Chapter 2

Responses to Comments

2.1 Distribution of the Recirculated Draft EIS/EIR

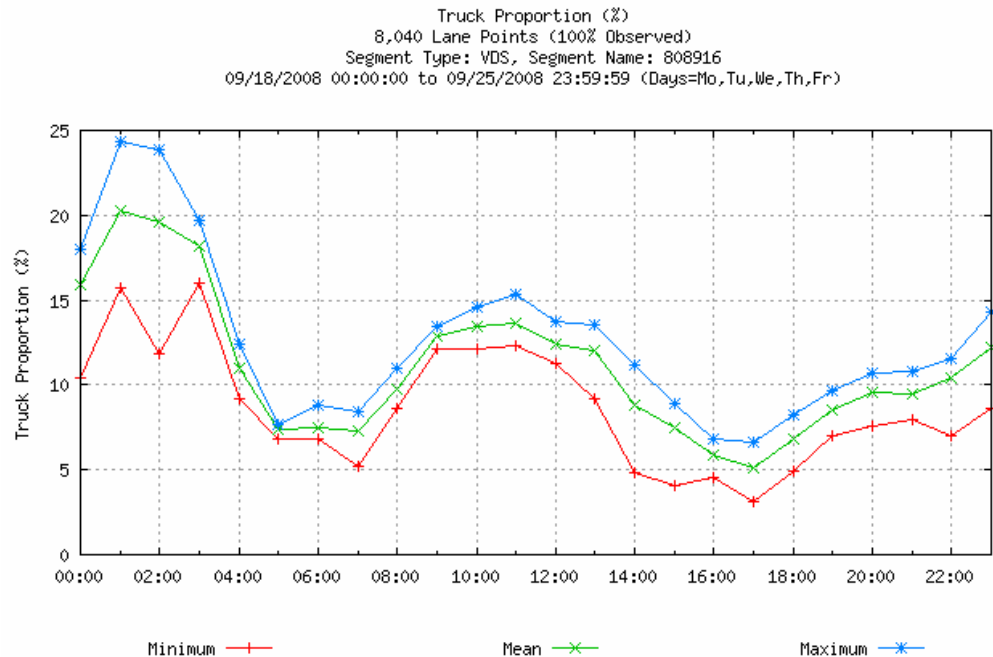
- 13-11** In response to the comment that the freeways in Riverside County are already congested with Port traffic, please see the responses to Comments 13-4 and 13-10 above. In addition, characterizing congestion in Riverside County as caused by the Ports is incorrect and unsubstantiated. Rather, congestion in Riverside County is predominantly a result of land use planning and growth policies and decisions of the jurisdictions within the county (please see the response to Comment 13-2 above).

RCTC suggests that trucks traveling at slower speeds will lead to a “slow-down of freeway traffic generally.” While trucks do travel at slower speeds than cars, the effects are not significant. A small change in speed will have a negligible impact on overall capacity. For example, a 5-mile-per-hour (mph) difference in free-flow speed (FFS) of the overall traffic stream translates to a difference of 50 vehicles per hour per lane in the capacity of a freeway, per the Highway Capacity Manual (HCM). If trucks travel 20 percent slower than the current average traffic, and 10 percent more trucks are added, the average travel speed will be reduced by less than 0.2 percent. Even a 1 percent difference in average speed would translate to a capacity difference of only 6 vehicles per hour per lane (or 24 vehicles per hour on a four-lane directional freeway). While this might be loosely interpreted as a “general slow-down,” it is not significant.

RCTC asserts that “trucks slowing down and merging leads to congestion and increases the likelihood of accidents.” While most research suggests that speed differentials do have an effect on safety, quantifying these effects due to a specific increase in truck volumes is not possible. Similarly, the congestion impacts of an increase in truck traffic can only be quantified if the exact volume of trucks on a specific freeway is known. Note also that the trucks in question (from Project traffic) are either through-trucks or trucks destined for local land uses (e.g., distribution centers, warehouses, or manufacturing facilities in Riverside County). Through-trucks do not use the ramps in Riverside County (i.e., they do not need to slow down and merge). Based on RCTC data, these are somewhat less than 50 percent of Port trucks in Riverside County (see page 2 of the *Critical Goods Movement Issues Scan for Riverside County*) (Cambridge Systematics, 2006). Furthermore, if trucks traveling on freeways within Riverside County slow down to exit the freeway or merge onto the freeway, it is because they are traveling to and from destinations such as businesses or warehouse facilities within the Inland Empire. These destinations or origins are likely land uses that have been approved by a local jurisdiction, which has also considered the environmental impacts of its approvals.

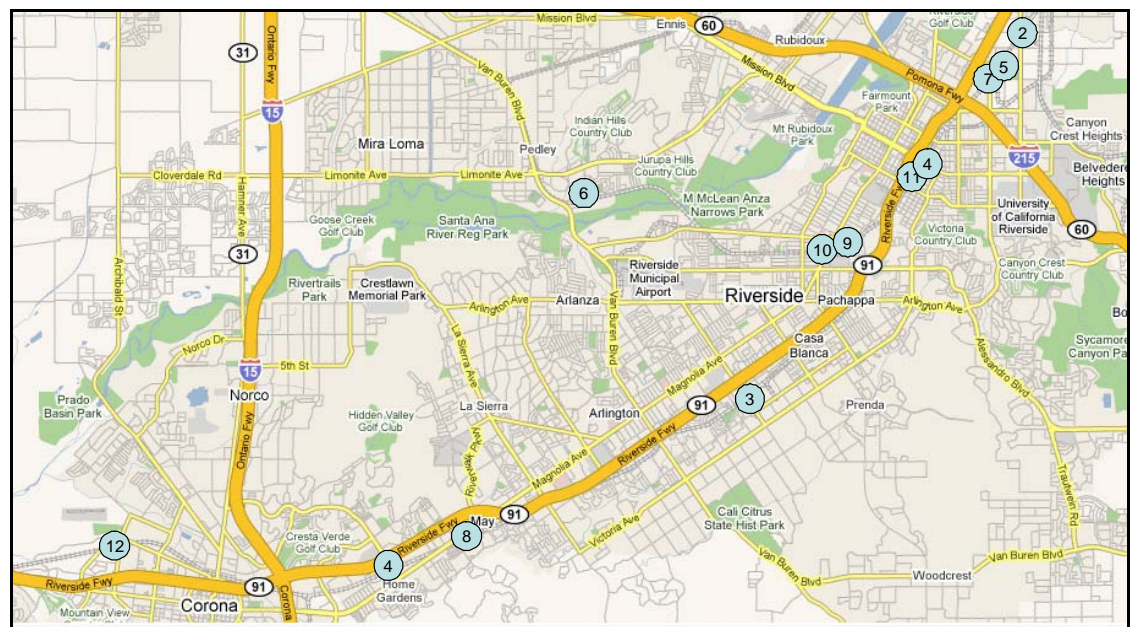
- + The total vehicle delay for the rail crossings provided by Kimley-Horn would be less than the total vehicle delay for a typical signalized intersection along a highway in Riverside County.
- + Signalized intersections within Riverside County form an integral part of traffic management.

- + The total vehicle delays at these signalized intersections are generally considered acceptable (as demonstrated by the ubiquitous nature of signalized intersections along County roadways).

Average vehicle delay, as evaluated in the Recirculated Draft EIS/EIR, would appear to be a better methodology for assessing significance (than using total vehicle delay), for the above reasons and because it is based on the Highway Capacity Manual. The analysis methodology is summarized in the formula on page 3.6-47 of the Recirculated Draft EIS/EIR (line 10), where the average delay is calculated for vehicles at grade crossings. The Recirculated Draft EIS/EIR includes the following delay calculation formula on page 3.6-47:
